Infonote

AO-IN-2022-023-I

Correction and Standardization of TOPLED Reverse Gullwing Package Dimensional Drawing in Datasheet

Objective:	Correction and Standardization of TOPLED Reverse Gullwing Package Dimensional Drawing in Datasheet
Affected products:	SFH 4253R; SFH 4257R; SFH 2270R; SFH 3211 FA; SFH 4246R
Reason for change:	<ul style="list-style-type: none"> • Correction of package dimensional drawing in datasheet • Standardization of package dimensional drawing in datasheet

Changes in the datasheets – Dimensional Drawing of SFH 4253R

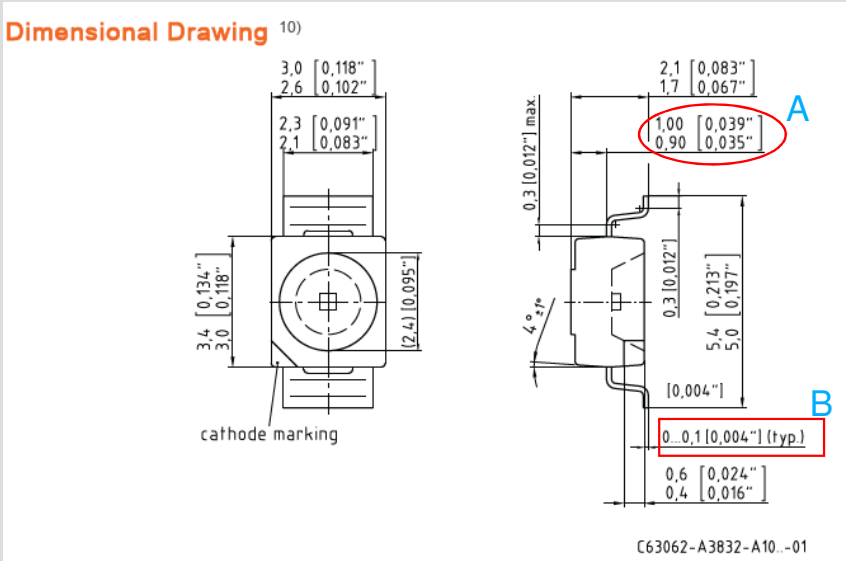
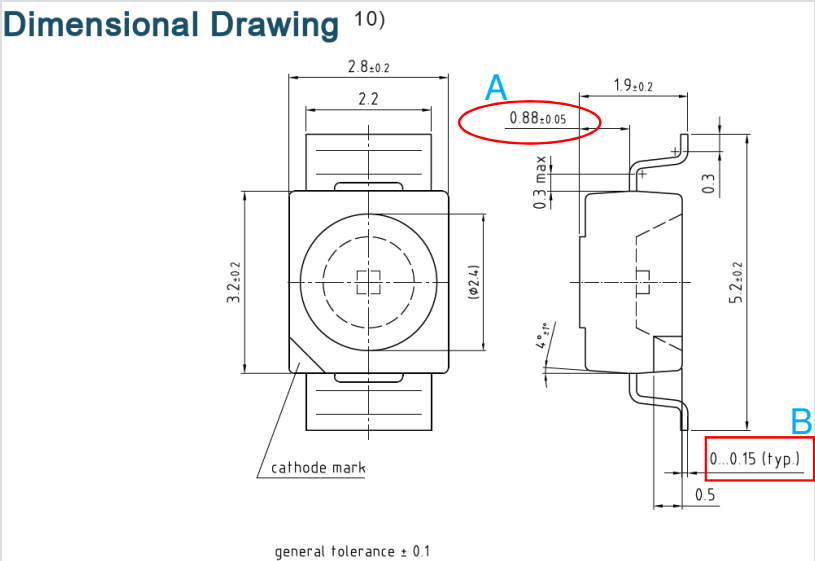
Current status	New status
<p>Dimensional Drawing 10)</p>  <p>C63062-A3832-A10.-01</p>	<p>Dimensional Drawing 10)</p>  <p>general tolerance ± 0.1</p>
<p>Incorrect dimension A: 0,90 – 1,00 B: 0.... 0,1</p>	<p>Correct dimension A: 0,88 ±0.05 B: 0.... 0,15</p>
